January 24, 2022

SCO ID# 20-21659-01A
REPAIRS TO NCDOT EDGEcombe COUNTY
EQUIPMENT & LUBE SHOPS

ADDENDUM No. 2

2 LUBE SHOP FLOOR PLAN
 SCALE: 1/8" = 1'-0"
 PLAN NORTH

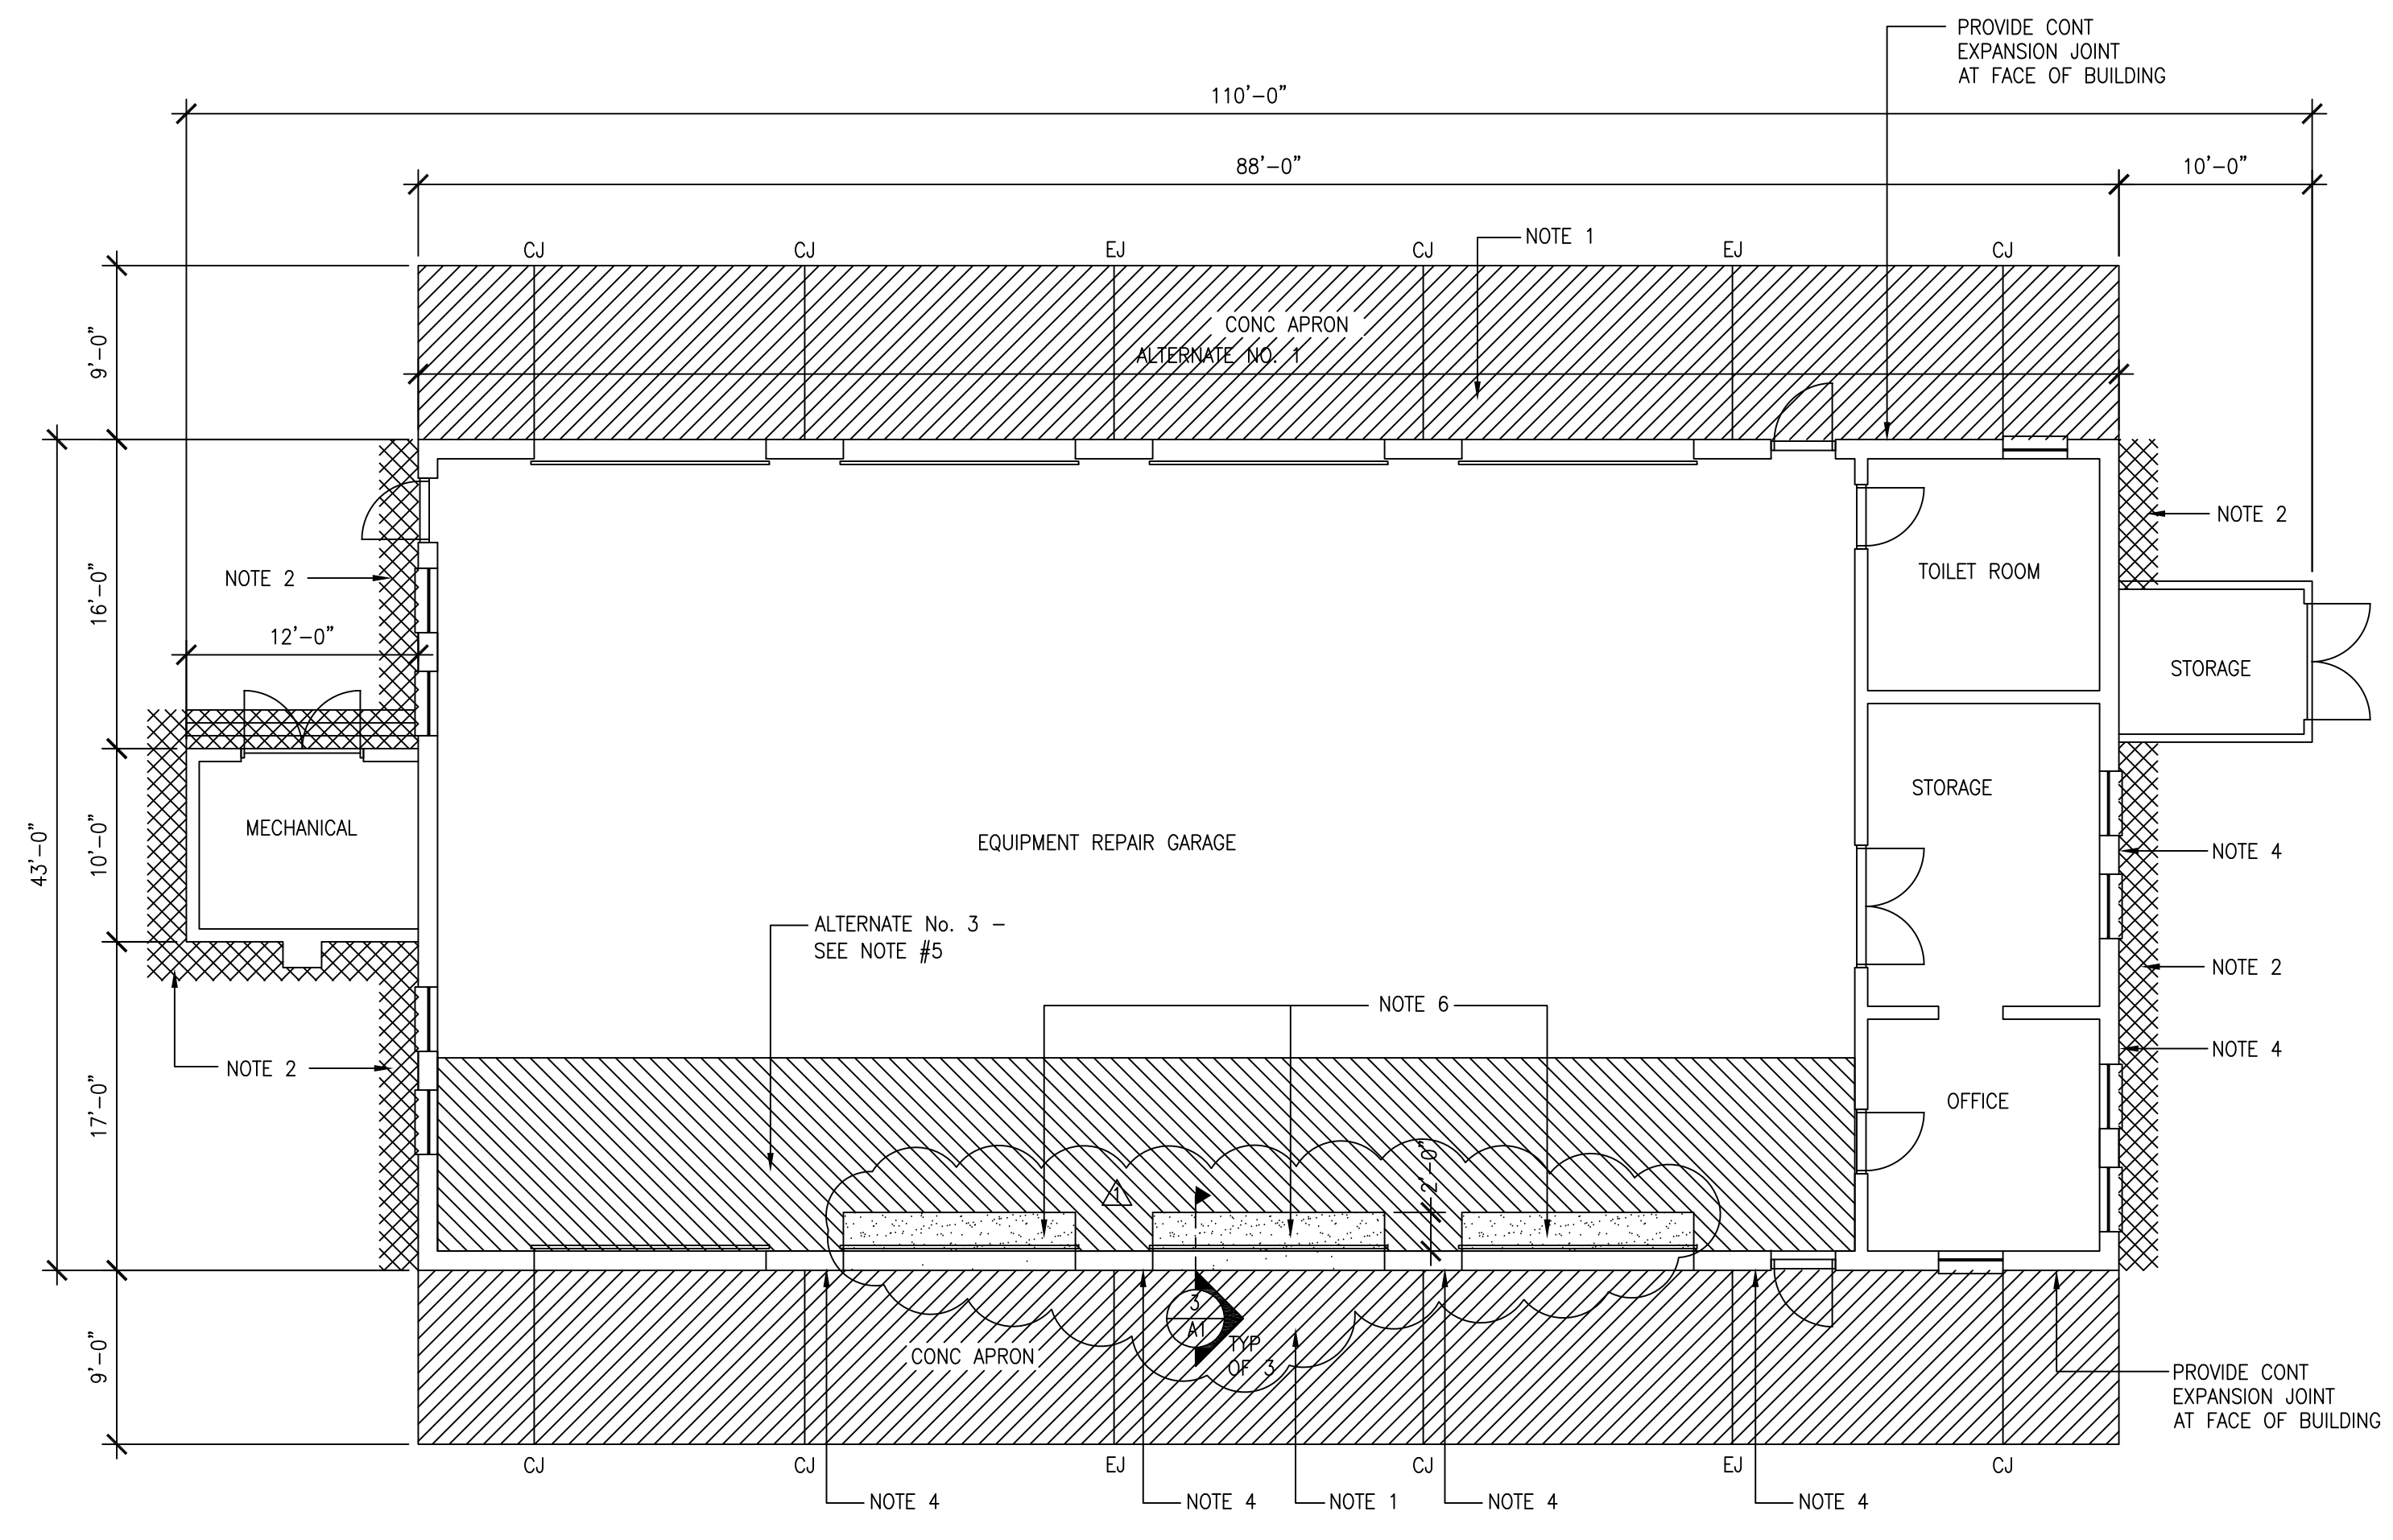
Item No. 9	Drawings S1, S2, & A1	Refer to Equipment and Lube Shop Floor Plans on Drawing A1 and Note No. 4 on Drawings S1 and S2. As part of the base bid, Foundation

Repair Contractor shall drill exploratory holes in the concrete floor slabs of both buildings at minimum four (4) feet on center each way in areas indicated.

1 EQUIPMENT SHOP FLOOR PLAN
 SCALE: 1/8" = 1'-0"
 PLAN NORTH

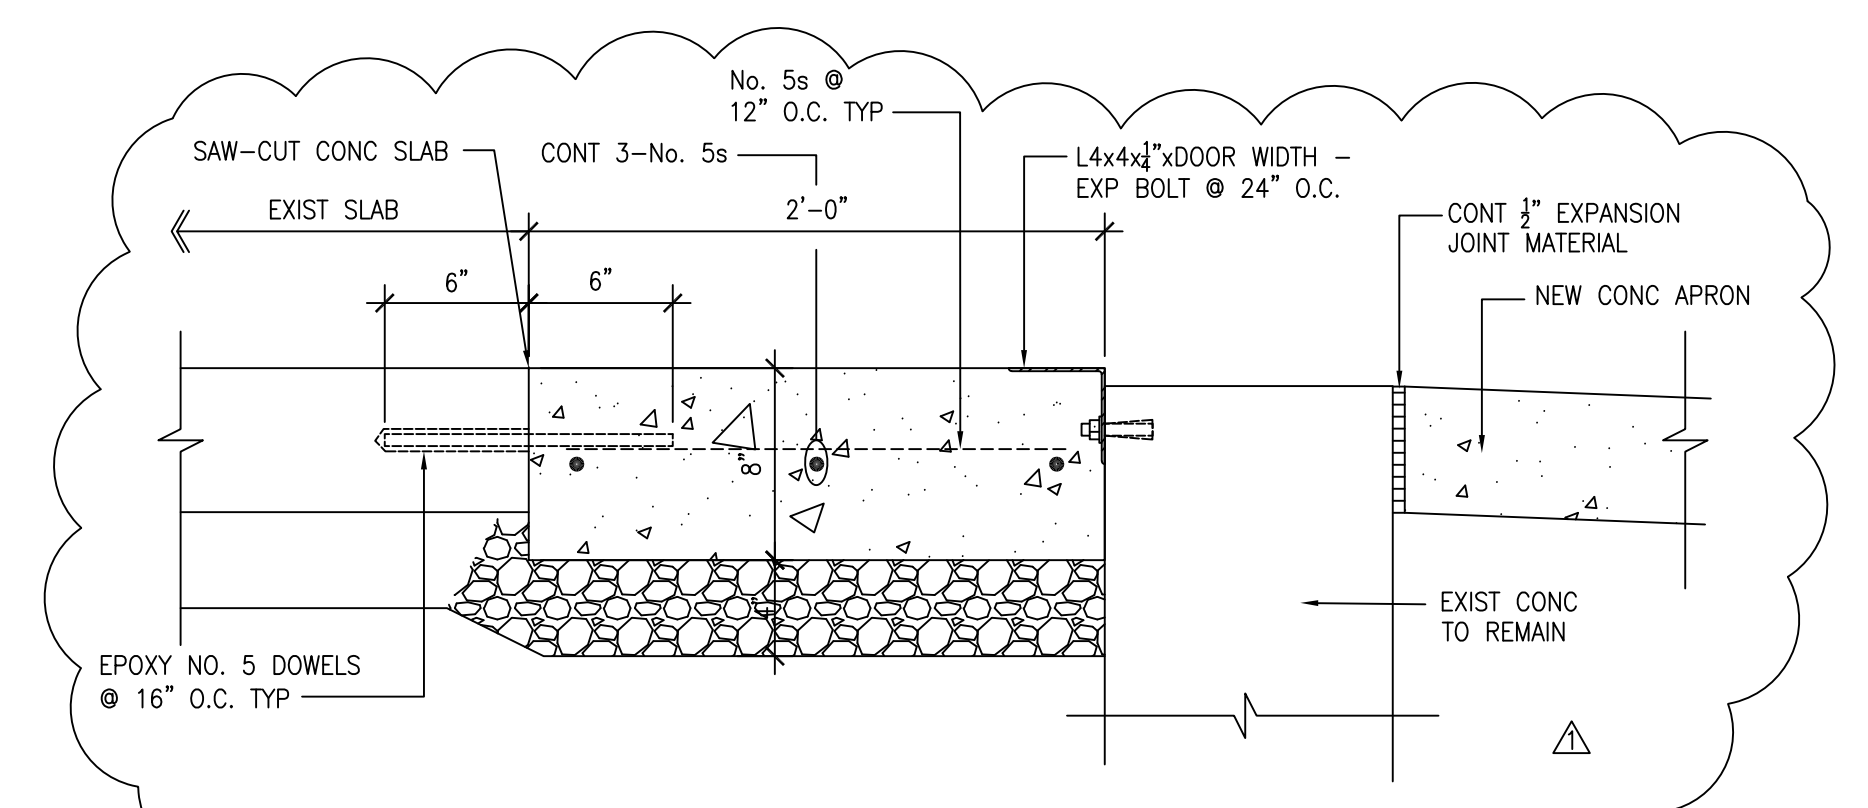
Item No. 1	Drawing A1	Refer to Equipment Shop Floor Plan 1/A1. See added requirement to saw-cut concrete floor slab to remove spalled and cracked areas at three (3) overhead doors per new Note 6 and new Detail 3/A1. See Attachment 'A'.

5. SEE SPECIFICATION SECTION 01 2300 "ALTERNATES" FOR CONCRETE FLOOR SLAB UNDERPINNING. SEE NOTE #4 ON DRAWINGS S1 AND S2.
6. SAW-CUT CONCRETE SLAB TO REMOVE SPALLED AND BROKEN CONCRETE. REINFORCE NEW CONCRETE AND DOWEL TO EXISTING SLAB PER DETAIL 3/A1. MATCH ADJACENT FINISH.

3 ROOF DETAIL
SCALE: 1/2" = 1'-0"

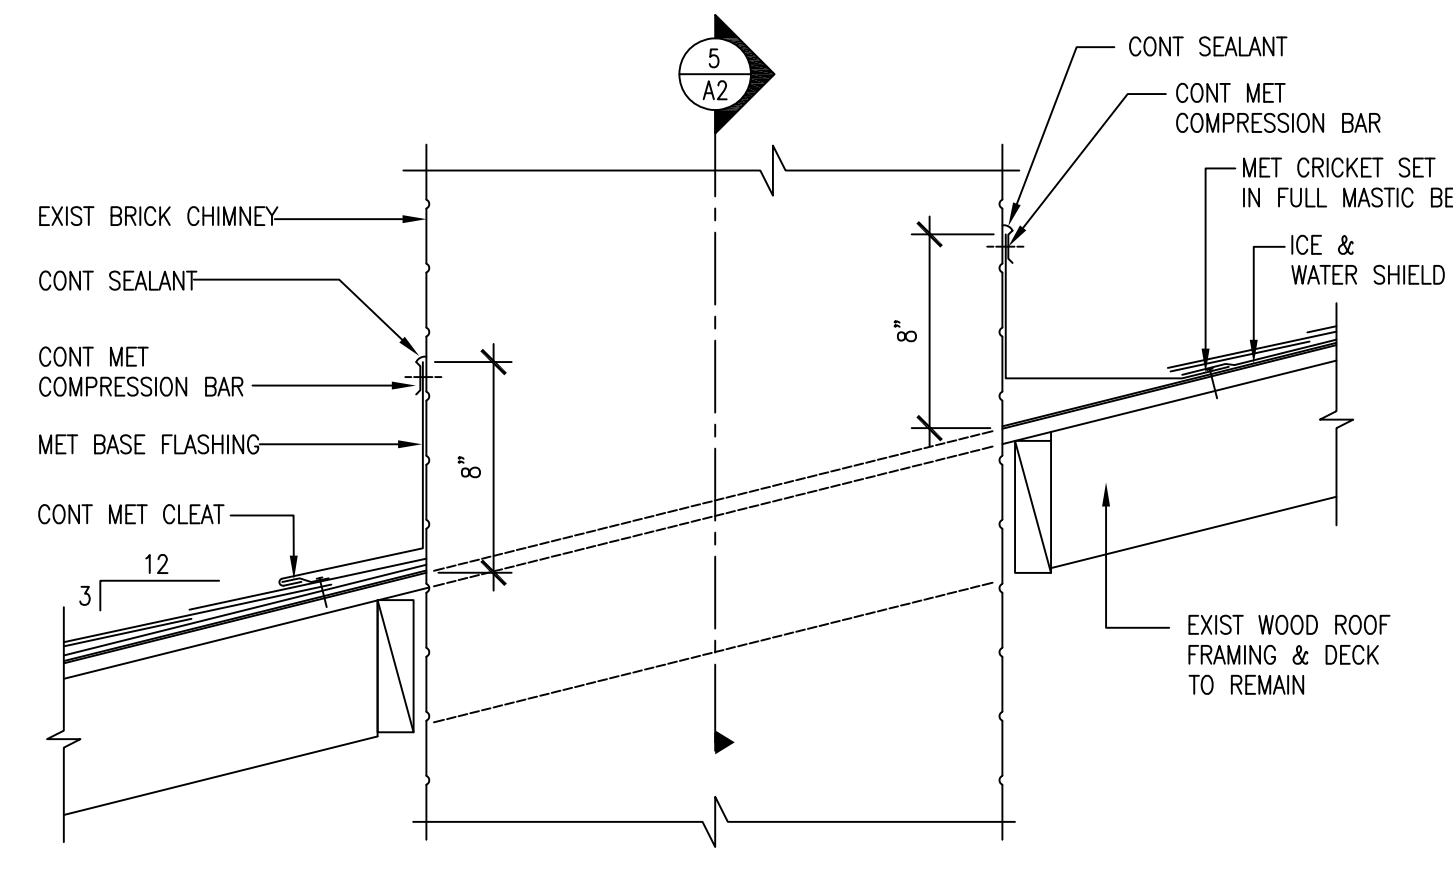
Item No. 2	Drawing A2	Refer to Detail 3/A2. All existing gutters at both buildings shall be removed and salvaged for re-use. All wood fascias at both buildings shall be demolished and replaced to match with PVC fascias. The Owner will reinstall the gutters. See Attachment 'B'.

6 RAKING CORNICE DETAIL
SCALE: 1/2" = 1'-0"

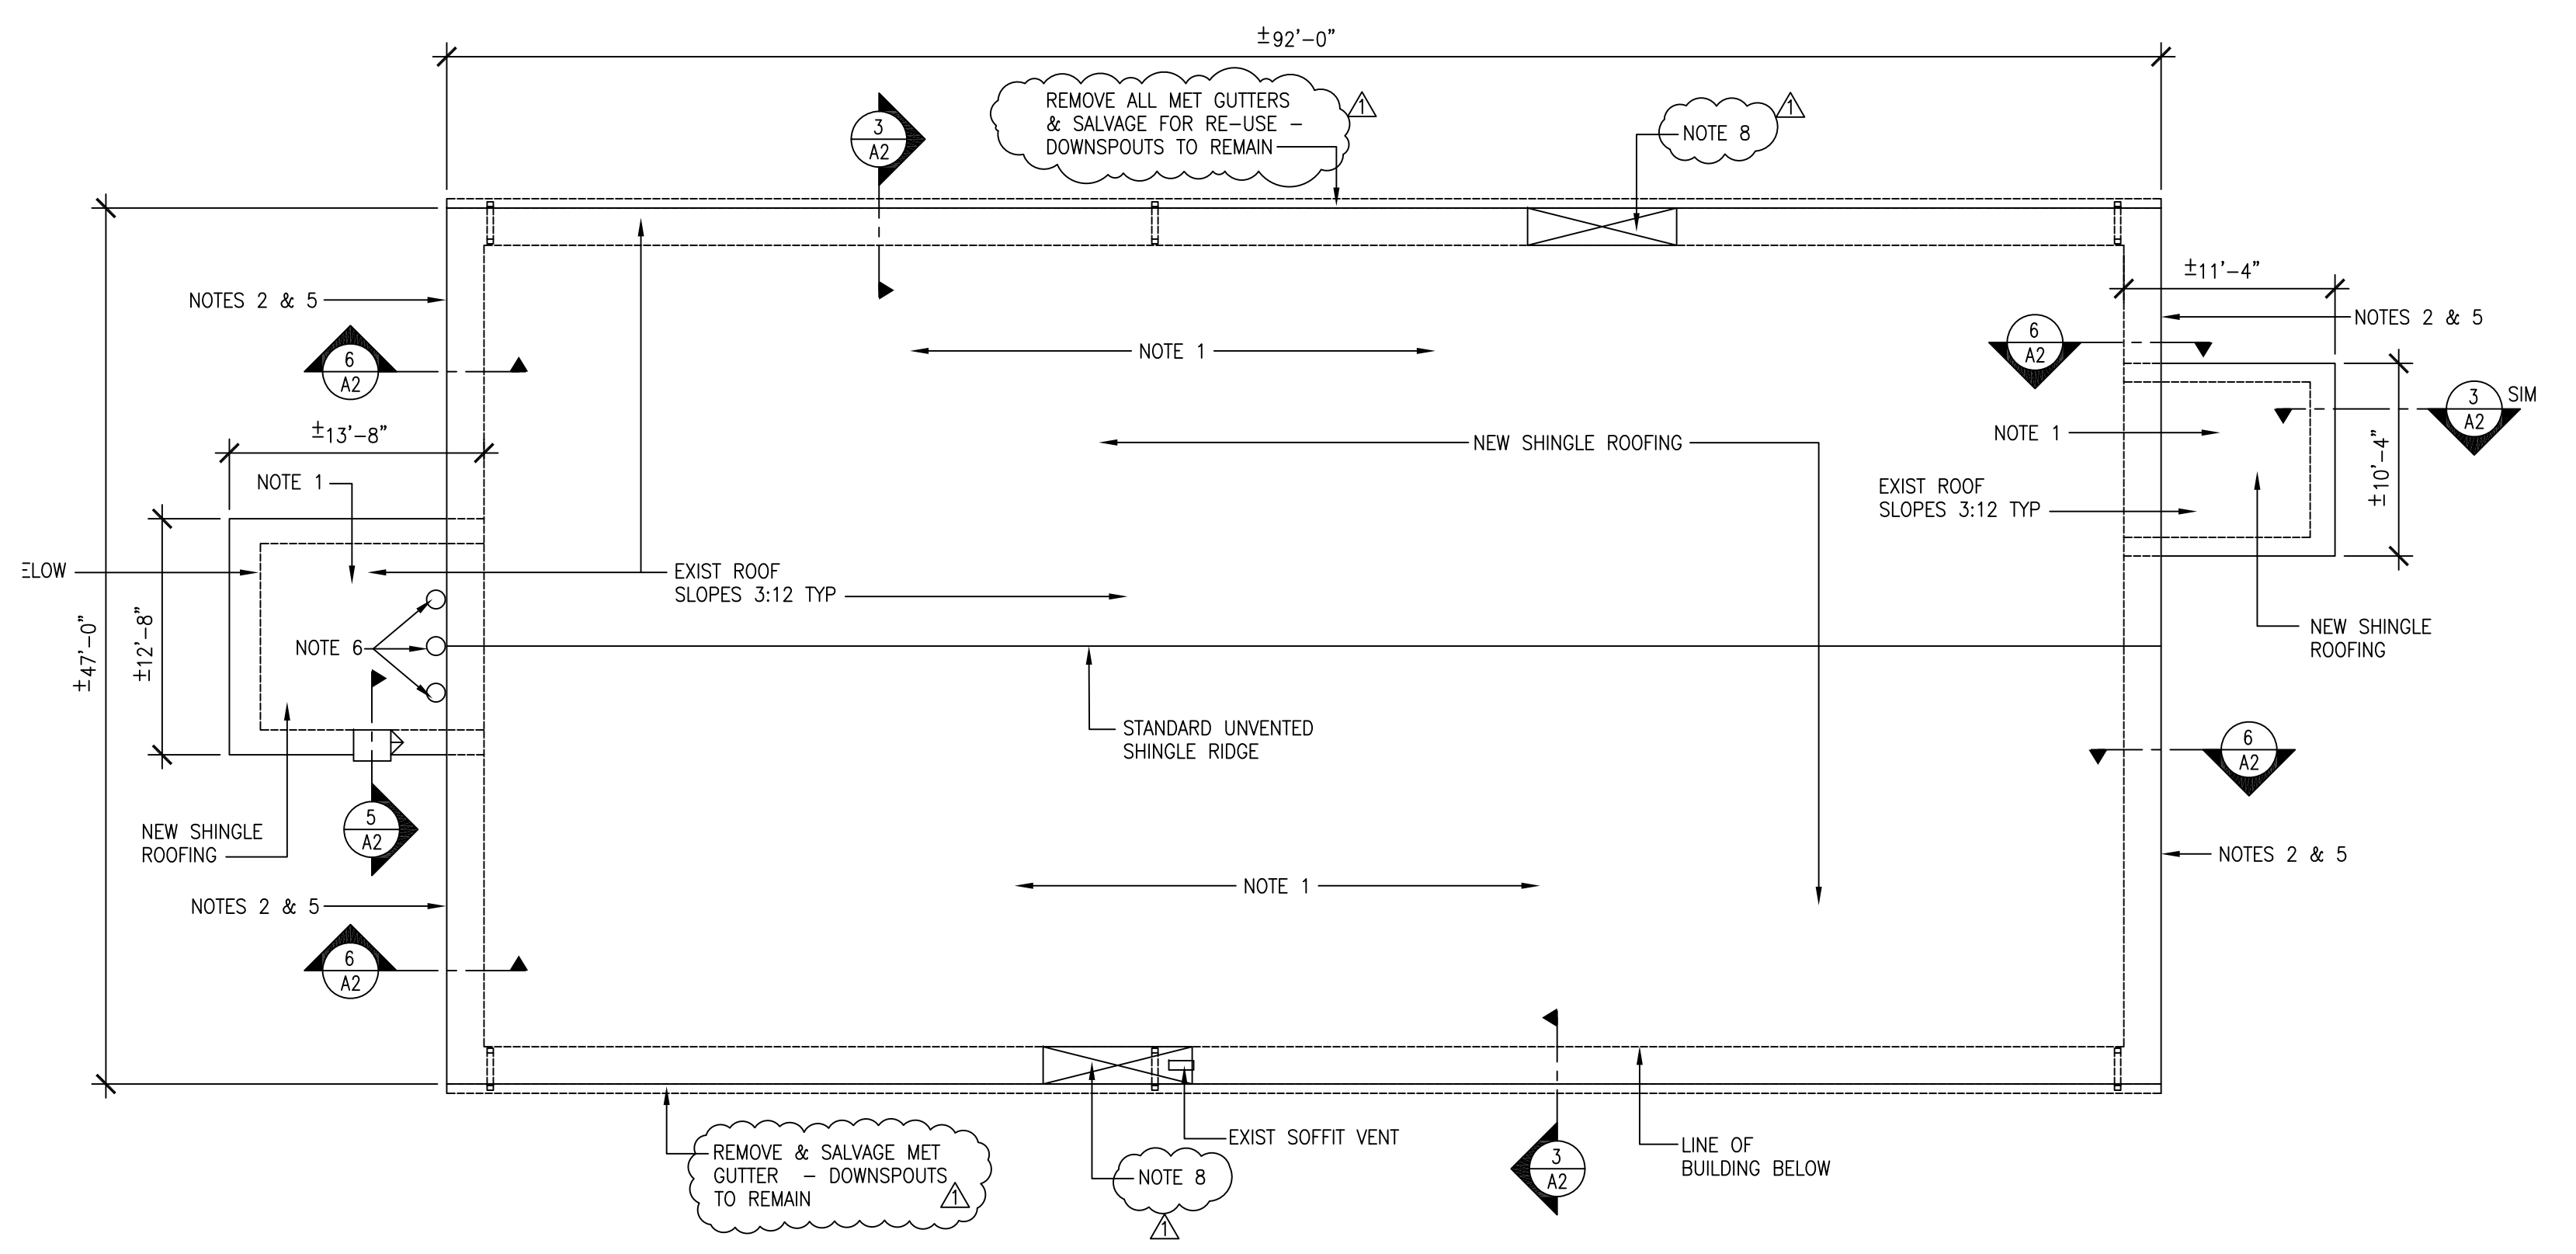
Item No. 4	Drawing A2	Refer to Lube Building Roof Plan 2/A2. The requirement for new gutter and downspouts has been deleted.
Item No. 5	Drawing A2	Refer to Detail 6/A2. Owner will remove all devices attached to existing raking cornices. See Attachment 'B'.
